ADDENDUM NUMBER THREE

DARLA MOORE SCHOOL OF BUSINESS CONSTRUCTION – BP-3
ENCLOSURE/SITE/MEFP/INTERIOR
UNIVERSITY OF SOUTH CAROLINA
STATE PROJECT NUMBER H27-6069-AC-3

DATE OF ISSUE: June 22, 2012

CONCRETE CHILLED WATER VAULT DETAIL REVISION
 REF. DWG # C1602

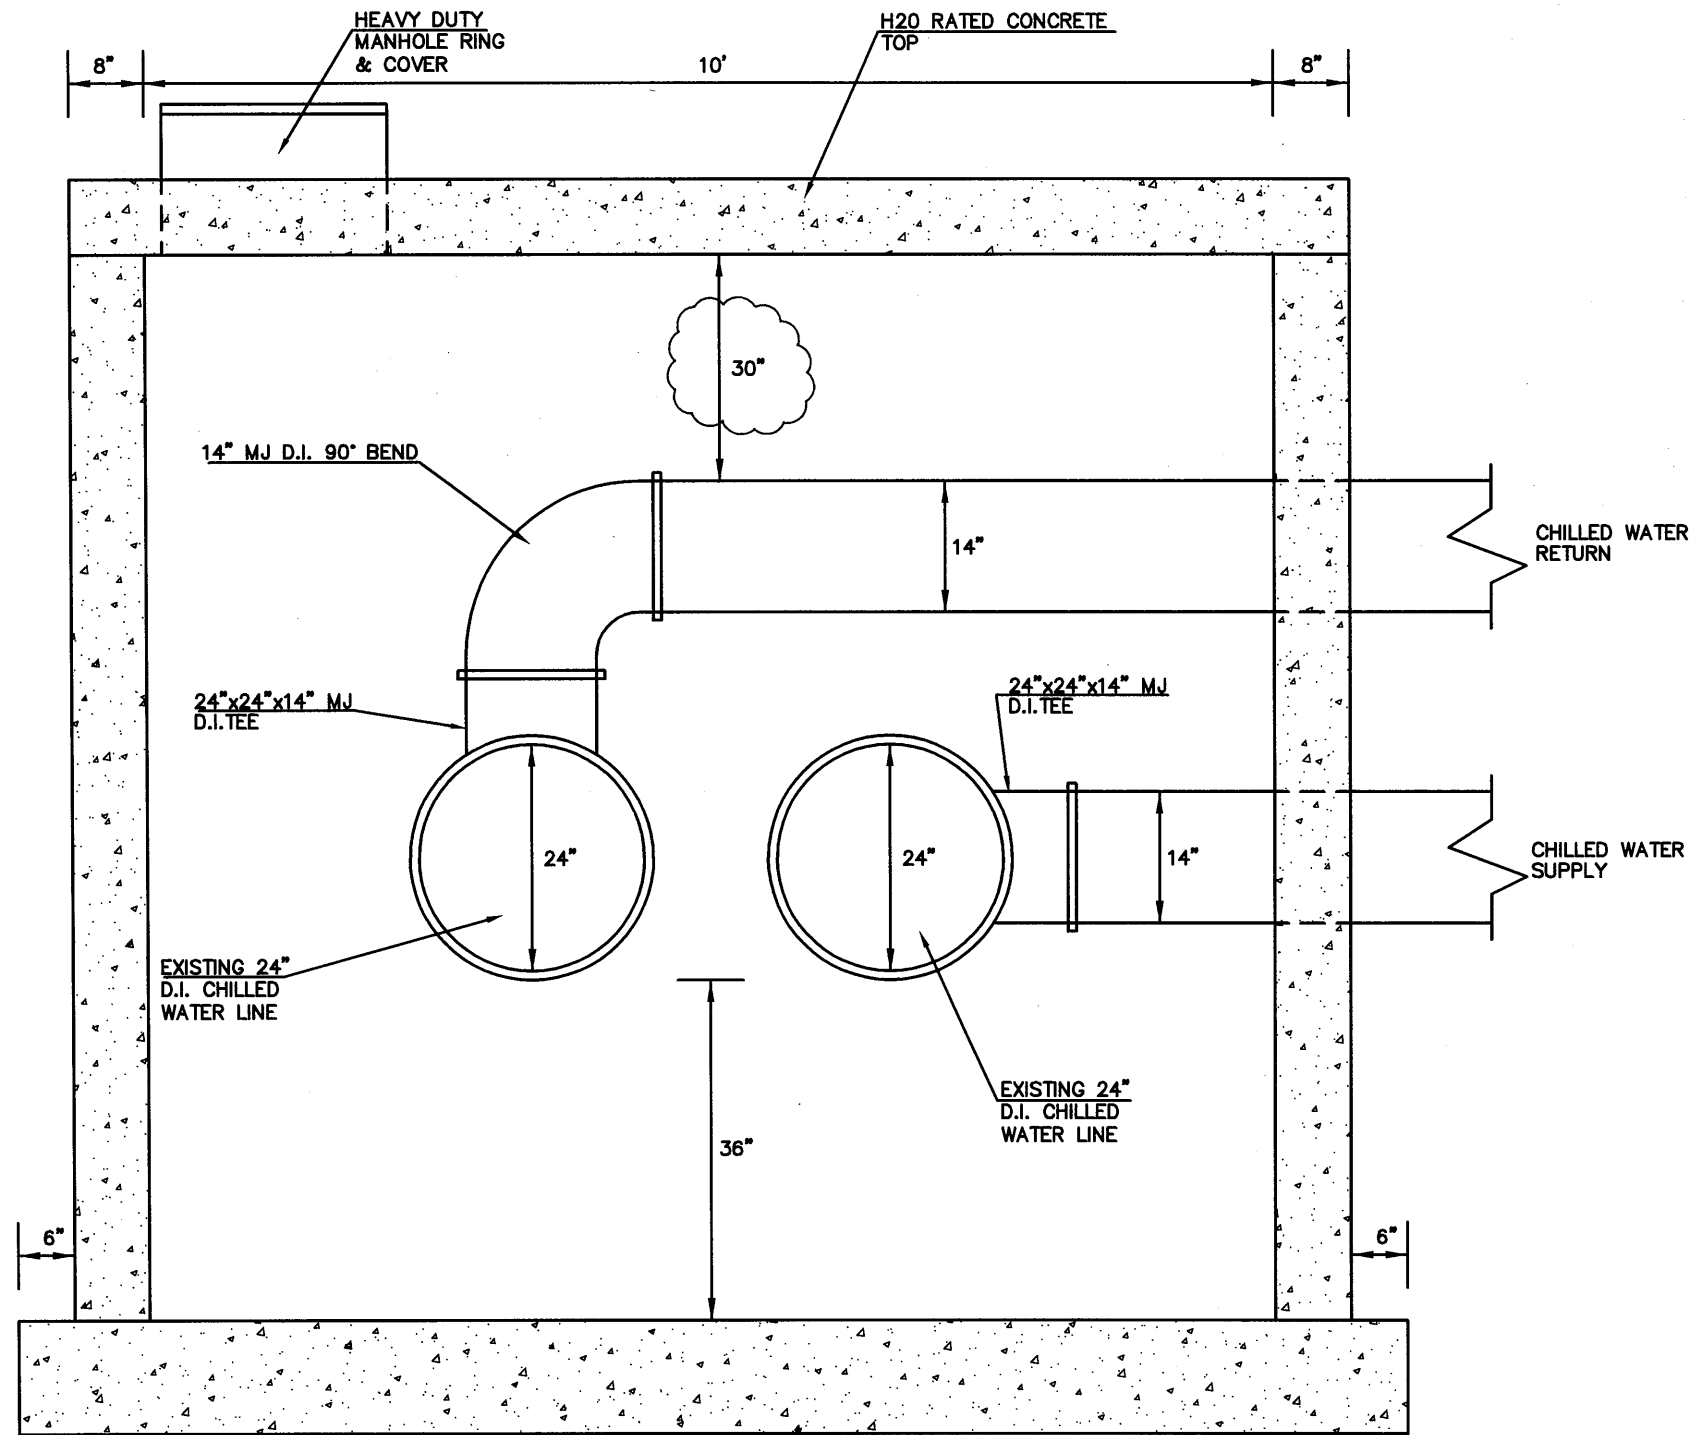
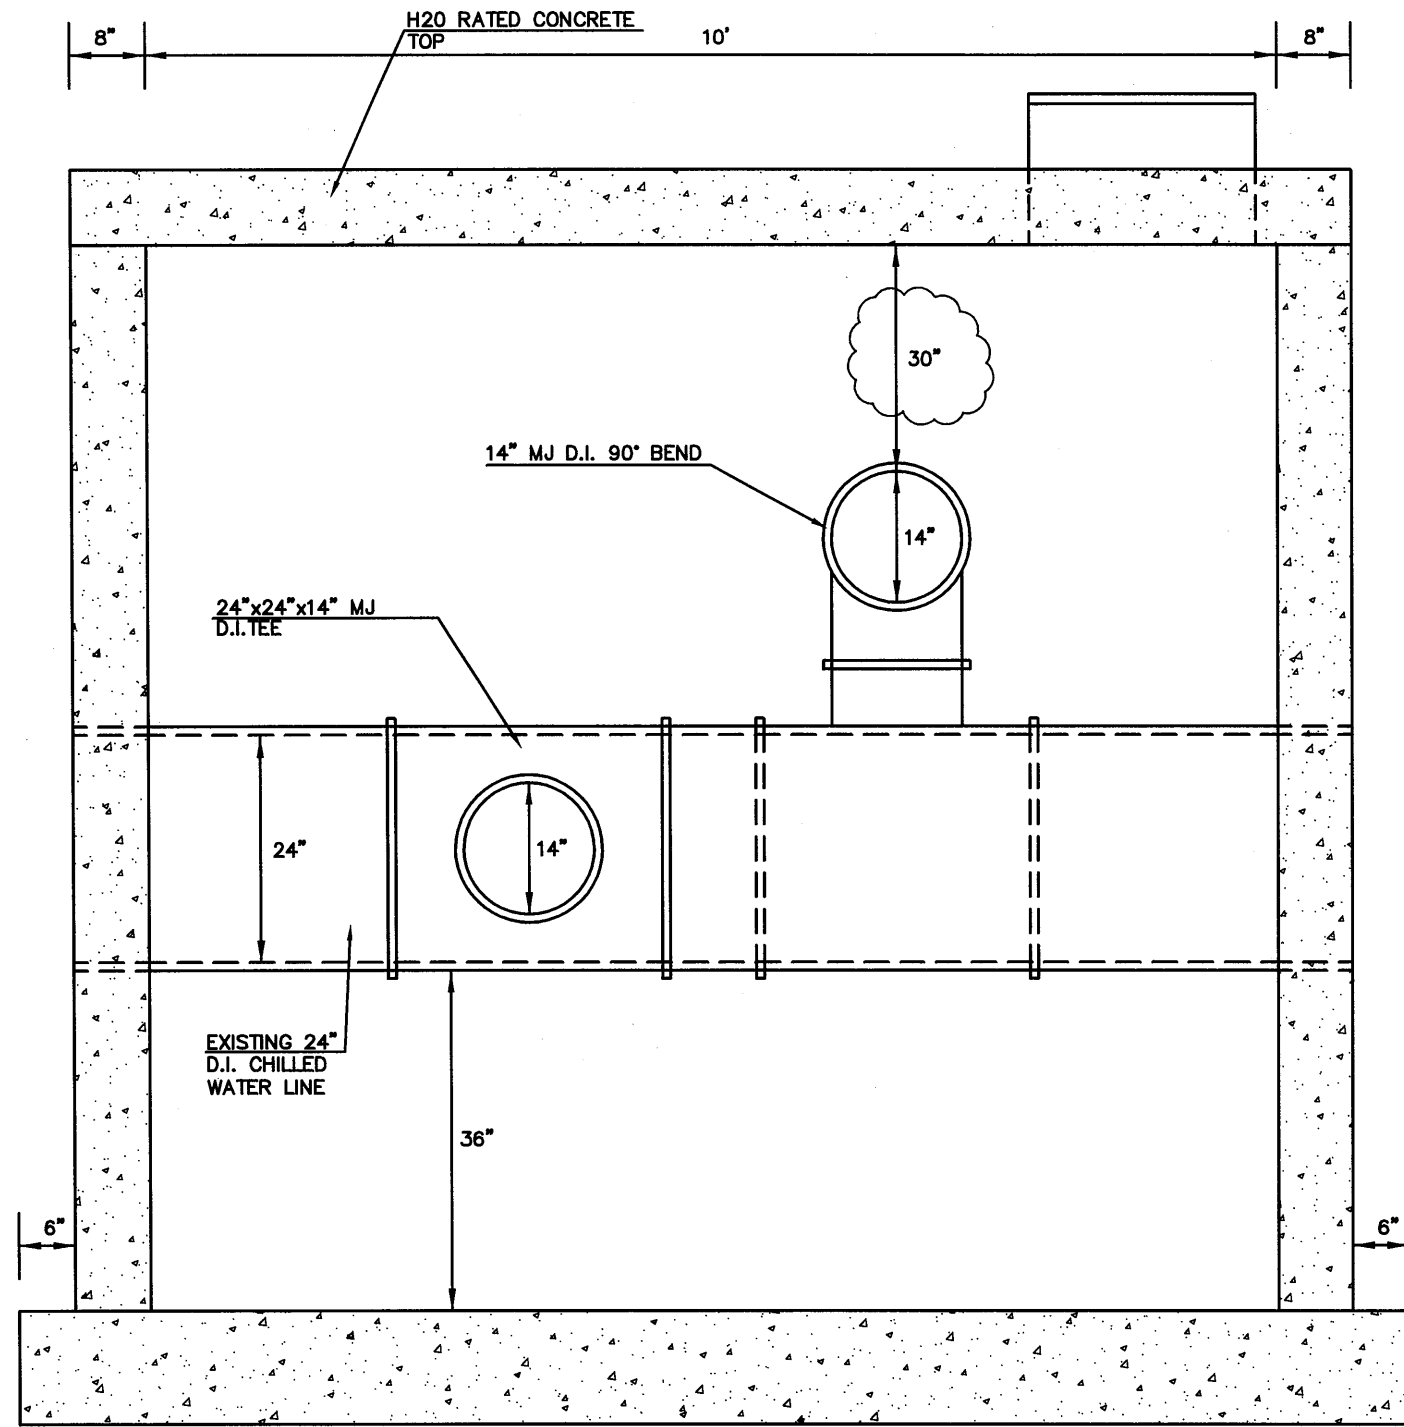
1. ADDENDUM THREE GENERIC SCHEDULE RECAP
2. C-SK-003: CONCRETE CHILLED WATER VAULT DETAIL REVISION
3. C-SK-004: CONCRETE CHILLED WATER VAULT DETAIL REVISION
4. C-SK-005: CONCRETE CHILLED WATER VAULT DETAIL REVISION
5. C-SK-006: CONCRETE CHILLED WATER VAULT DETAIL REVISION
6. C-SK-007: EXTENT OF PAVEMENT REMOVAL/REPAIR FOR STEAM/CONDENSATE LINE WORK REVISION
7. C-SK-008: EXTENT OF PAVEMENT REMOVAL/REPAIR FOR STEAM/CONDENSATE LINE WORK REVISION
8. C-SK-009: RAINWATER HARVESTING SYSTEM LAYOUT REVISION
9. C-SK-010: ROOF DRAINAGE COLLECTOR LINE C PROFILE REVISION
10. C-SK-011: LOCATION OF RAINWATER HARVESTING SYSTEM TANK & FIRE WATER TANK REVISION
